Agenda Item # 6 SUB-003569-2025

North Ridgelawn – Ravine Subdivision

- Subdivision approval to create two (2) legal lots of record from two (2) metes-and-bounds parcels.

APPLICATION NUMBER 6 DATE January 15, 2026

DETAIL SITE PLAN

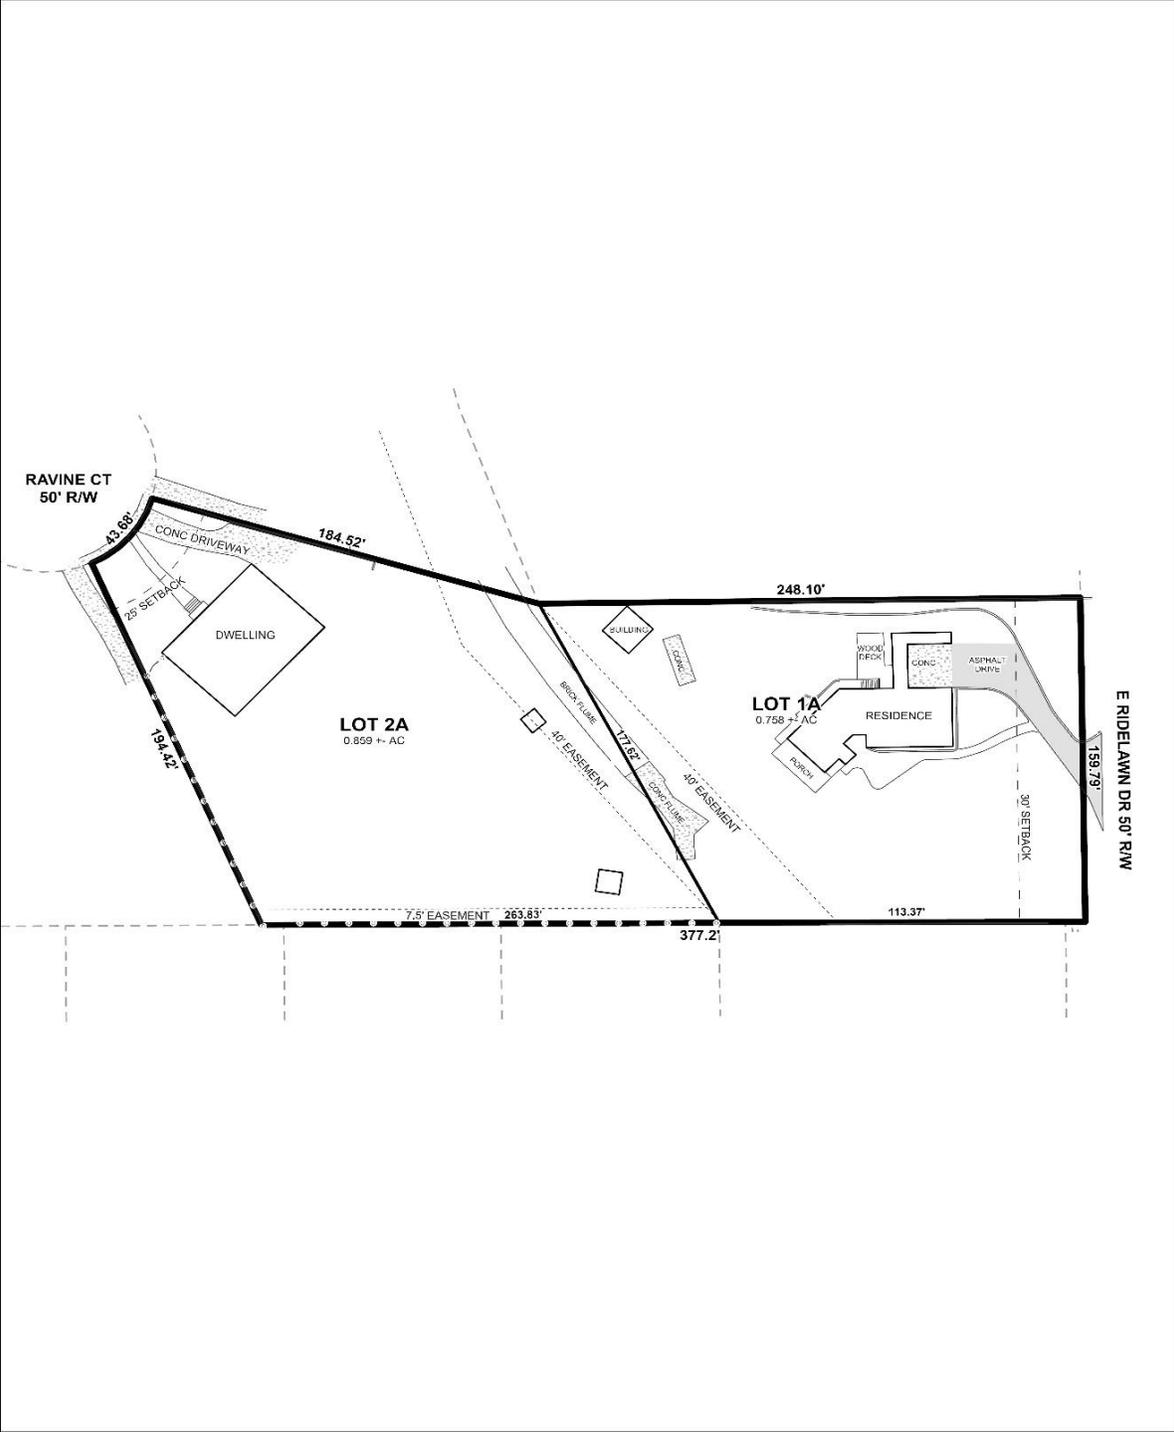
Proposed Lot 2A has frontage on Ravine Court, and proposed Lot 1A has frontage on Ridgelawn Drive East. Both are minor streets with curb and gutter, each requiring a 50-foot-wide right-of-way. Sufficient rights-of-way are depicted along both street frontages on the preliminary plat, making additional dedication unnecessary. If approved, the rights-of-way should be retained on the Final Plat.

Ridgelawn Drive East is incorrectly labeled as “East Ridgelawn Drive” and should be corrected on the Final Plat, if approved.

The preliminary plat illustrates the required 25-foot front yard setback along both street frontages, in accordance with Article 2, Section 64-2-14.E. of the UDC and Section 6.C.8. of the Subdivision Regulations. If approved, the front yard setbacks should be retained on the Final Plat.

Multiple drainage and utility easements are illustrated on the preliminary plat. If approved, placement of a note on the Final Plat stating that no structure shall be constructed in any easement without permission of the easement holder should be required.

1. Retention of rights-of-way along Ravine Court and Ridgelawn Drive East, as depicted on the preliminary plat;
2. Revision of the plat to correctly label Ridgelawn Drive East.

3. Retention of the lot sizes in both square feet and acres, or the provision of a table on the Final Plat providing the same information, adjusted for any required dedication;

4. Retention of the required 25-foot front yard setback along all street frontages, in compliance with Article 2, Section 64-2-10.E. of the UDC and Section 6.C.8. of the Subdivision Regulations, adjusted for any required dedication;

5. Placement of a note on the Final Plat stating that no structure may be constructed or placed within any easement without the permission of the easement holder;
